2 February 2025

Proposed redevelopment of church at 58a Birkenhead Street, 2024/5792/P

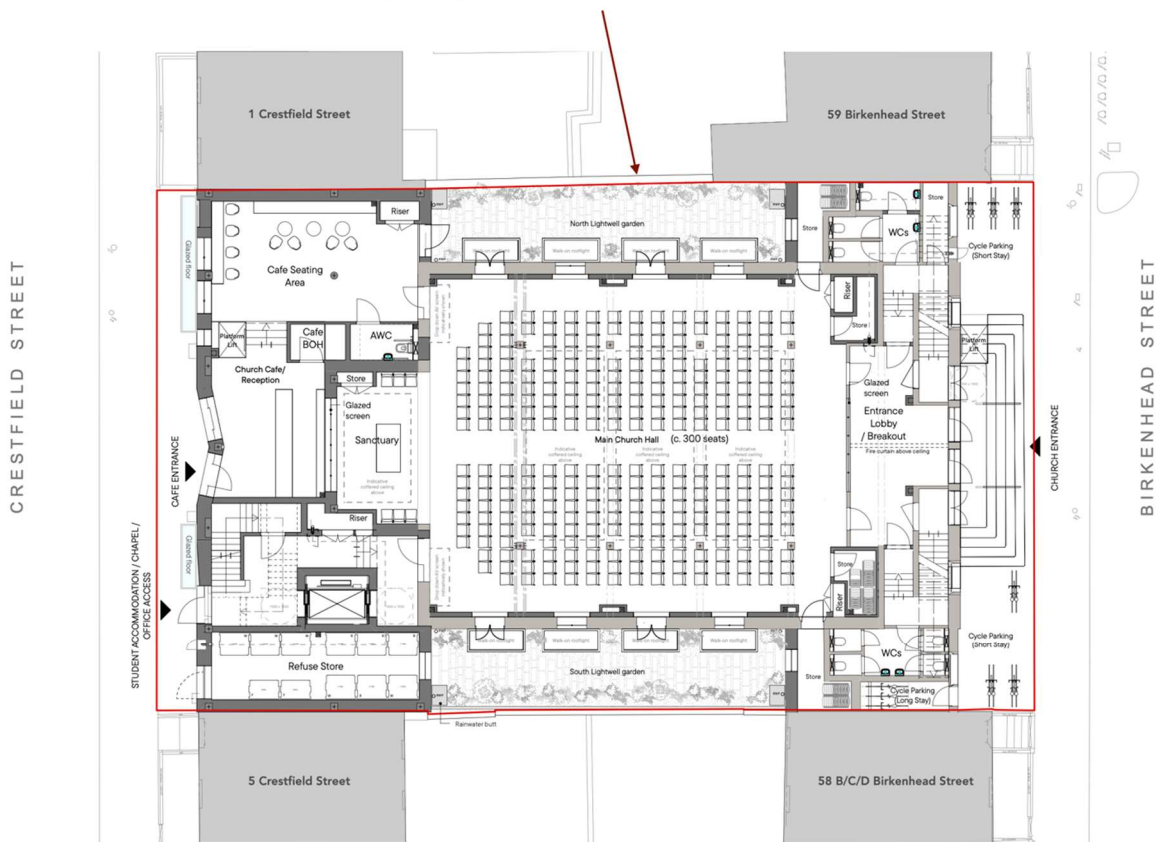
As in diagram below (Proposed Ground Floor Plan), the extent of 59 Birkenhead St is not shown correctly and a window facing directly onto the proposed garden is not shown. No mention is made in the proposal or the light survey of this window, which will be almost completely covered by the raised outdoor space bordering it. Planning and amenity issues surrounding this window are not addressed.

Plan does not show existing building nor the window which faces directly onto the proposed lightwell garden. Privacy issues not addressed nor any impacts on light and sky to this window.

We ask that the planning and amenity issues, including light and sunlight, revolving around the ignored window on the south side of our property be addressed in the light of an accurate plan.

Figure 1: Equipment location, measurement position, and closest receptor (available at [google.com/maps](https://www.google.com/maps))

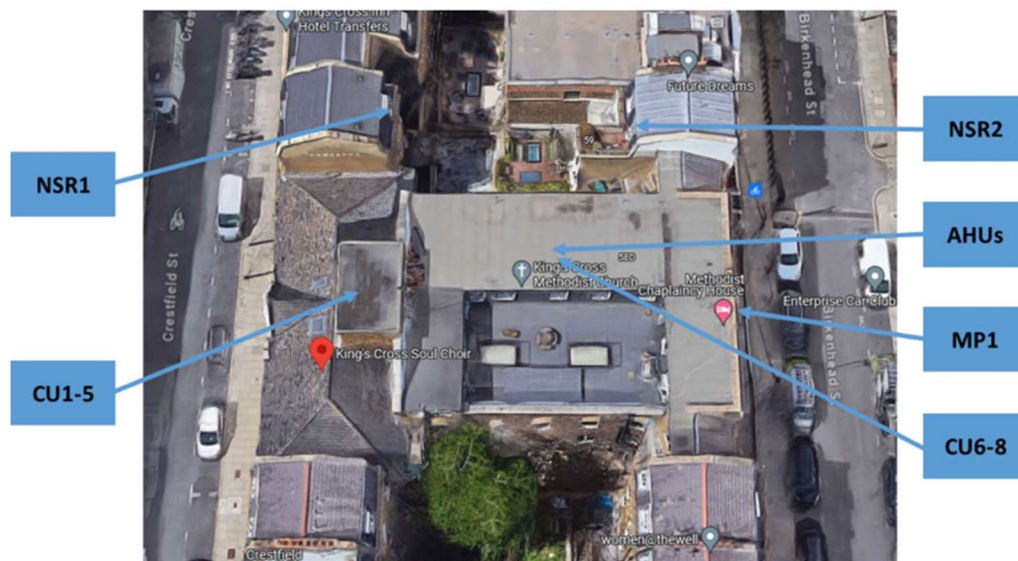
The acoustic assessment has not made a proper assessment of background noise levels to the rear windows or outdoor areas to 59 Birkenhead Street. Noise levels were recorded at 'MP1' in both noise reports which faces directly onto the street and is therefore almost certainly louder than the window location used for the assessment, NSR2 (diagram below).

Thus the following statement, and possibly others, cannot be relied upon, "Table 6 shows the rating level of the proposed new equipment will be at least 10dB below the background LA90 sound level to outside the closest noise-sensitive properties."

The model used to make the estimates has not been disclosed. However, it is clear that this model makes no attempt: to account for the reduction in background sound level to be expected from the increased enclosure of NSR2 by the larger edifice of the church; to include the stops and starts of noise, which are liable to be the aspects of any machinery that disrupts sleep the most, including failing to disclose the operating parameters in this regard provided by the manufacturers of the equipment and expected usage patterns; to account for the additive effect of the two bedroom openings that face the machinery; to allow for the reflection of sound, including reverb, from the enclosing buildings; to incorporate noise from sources not in the main machinery space (for example in the plant room and as shown on the roof plan). These deficiencies again undermine the conclusions drawn.

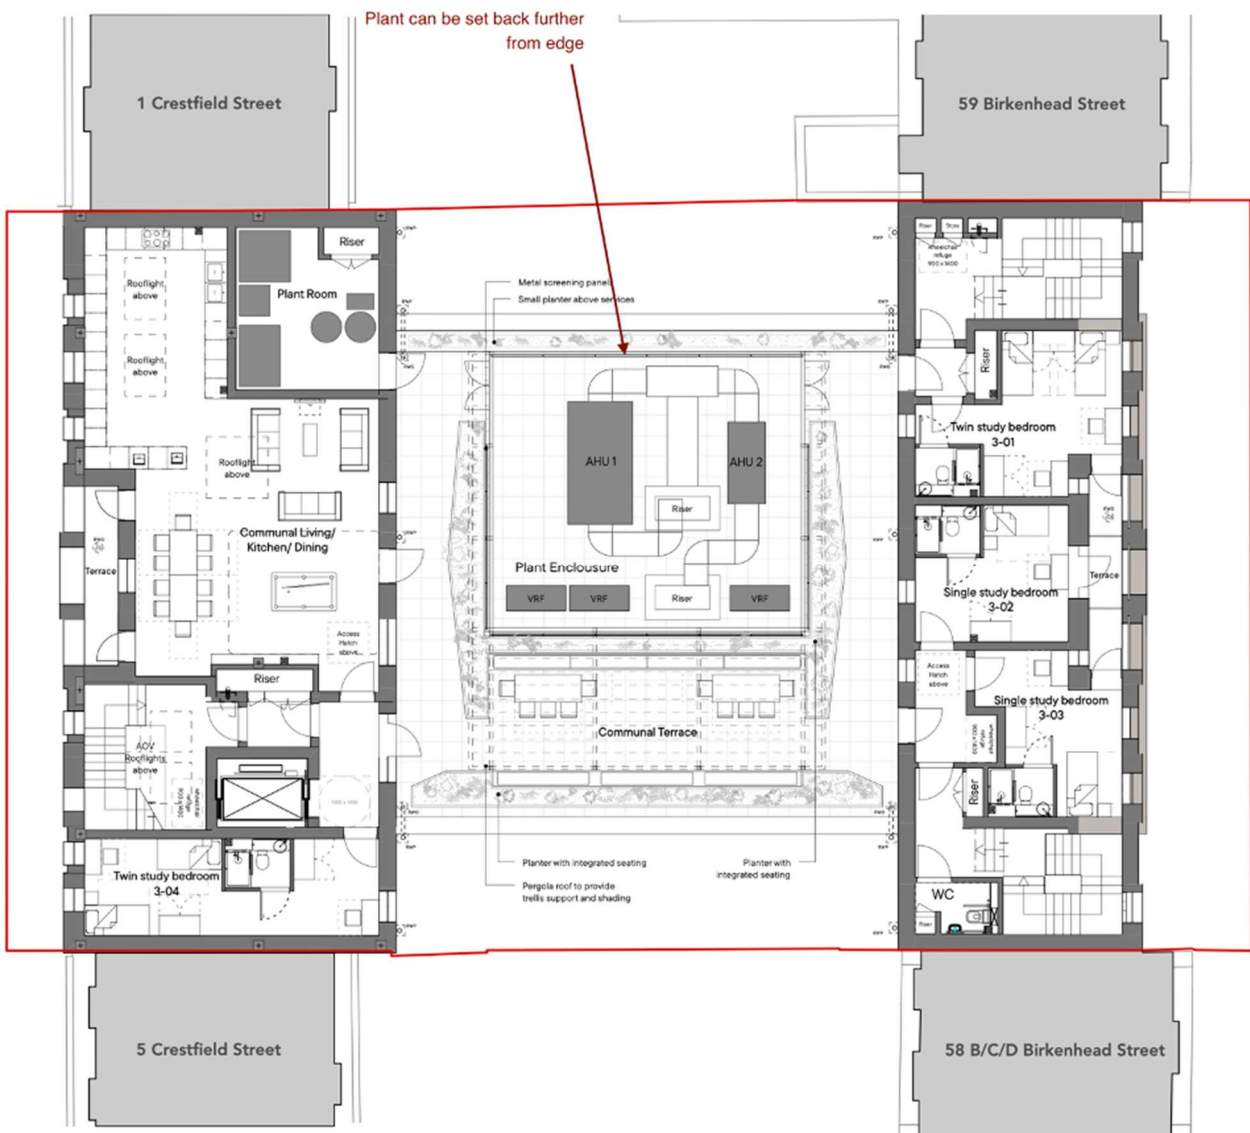
- Instead of raising the parapet on the north side, put in railings; use alternative methods to avoid any consequent overlooking or increase in experienced noise that is introduced.
- Reduce the loss of amenity caused by the machinery. In this:
 - Treat disturbance to our sleep with no less care than is afforded to disturbance to the sleep of the students
 - Improve the realism of the model by re-measuring the background noise levels and taking account of the several complicating factors mentioned above
 - Model the noise to be expected on our balcony and ensure it is acceptable
 - Remove the need for mechanical ventilation by working harder at making passive cooling in the summer effective
 - Whatever machinery is ultimately required, move it away from our bedroom and improve insulation (diagram below)
